Access Compliance Report

Public Rights-of-Way

Intersection ID: 48193	Main Street: BLAKENEY CENTRE DR	Cross Street: BLAKENEY PROFESSIONAL DR	Location: SE
ADA ID: 0D99A981CD82	Ramp Type: PerpDiag	Initial Pass/Fail: Fail	Overall Compliance: No
Codes/Mitigation Info/Possible Solution		Field Measurements/Component Compliance

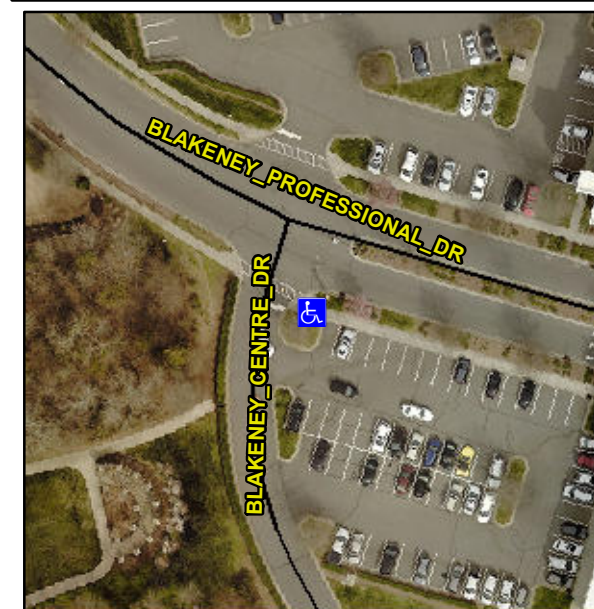
Not Found, R304.2.2, R304.5.3

Compliance	Description	Data	Compliance	Description	Data
N/A	Ramp Length (in)	50.0	No	Ramp Slope (%)	8.6
Yes	Ramp Width (in)	50.0	No	Ramp XSlope (%)	5.3
N/A	Flare Type LT	N/A	N/A	Flare Type RT	N/A
N/A	Flare Slope LT (%)	N/A	N/A	Flare Slope RT (%)	N/A
N/A	Flare Traversable LT?	N/A	N/A	Flare Traversable RT?	N/A
N/A	Landing Length (in)	N/A	N/A	DWS Provided?	N/A
N/A	Landing Width (in)	N/A	N/A	DWS Contrast?	N/A
N/A	Landing Slope (%)	N/A	N/A	DWS Length (in)	N/A
N/A	Landing X Slope (%)	N/A	N/A	DWS Full Width?	N/A
N/A	Landing Curb? (Y/N)	N/A	N/A	DWS Offset (in)	N/A
N/A	Shared Landing?	N/A			
N/A	Gutter Ponding?	N/A	N/A	Gutter Slope (%)	N/A
N/A	Gutter Lip Ht (in)	N/A	N/A	Gutter X Slope (%)	N/A
N/A	Painted X Walk1?	No	N/A	Painted X Walk2?	Yes
	X Walk 1 Direction	To N		X Walk 2 Direction	To NW
N/A	X Walk 1 Width (in)	N/A	N/A	X Walk 2 Width (in)	56.0
	X Walk 1 Slope (%)	1.0		X Walk 2 Slope (%)	3.8
	X Walk 1 X Slope (%)	3.1		X Walk 2 X Slope (%)	2.3

Remove & Replace Curb Ramp With Two New Directional Ramps or Equivalent.
